2022/2644/L – Flat 6, 3 Cambridge Gate, London, NW1 4JX

Delegated Report	Analysis sheet	Expiry Date: 16/9/22			
(Members Briefing)	N/A	Consultation Expiry Date:			
Officer		Application Number(s)			
Alan Wito		2022/2644/L			
Application Address		Drawing Numbers			
Flat 6 3 Cambridge Gate London Camden NW1 4JX		See draft decision notice			
PO 3/4 Area Te	am Signature C&UD	Authorised Officer Signature			
Proposal(s)					
Installation of internal s elevations.	econdary glazing to 15 windows	on 3rd to 5th floors to front and rear			
Recommendation:	Grant conditional listed building consent				
Application Type:	Listed building consent

Installation of internal secondary glazing to 15 windows on 3rd to 5th floors to front and rear elevations.

Photo 1: Windows on front elevation where secondary glazing is proposed

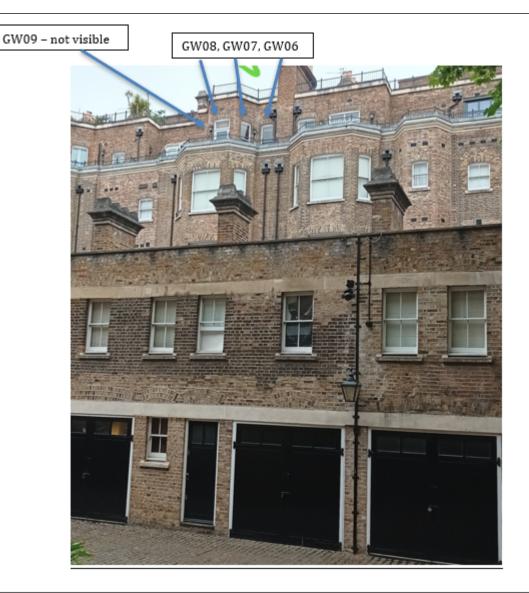
- 2.2. The CAAC requested that the outer face of the secondary glazing is coloured grey which would help it blend in with the darker room interior in views from the outside. The manufacturer producing the secondary glazing advised that they did not provide a dual colour product. Online research did not reveal any manufacturers who could provide this.

- 2.3. Whilst a grey colour might help reduce the visual impact of the secondary glazing from the outside, white frames would not have an adverse impact as they would match the colour of the existing windows. Also the windows are a considerable height above pavement level, at third floor level and above, at which distance the thin framing of the secondary glazing will not appear prominent.
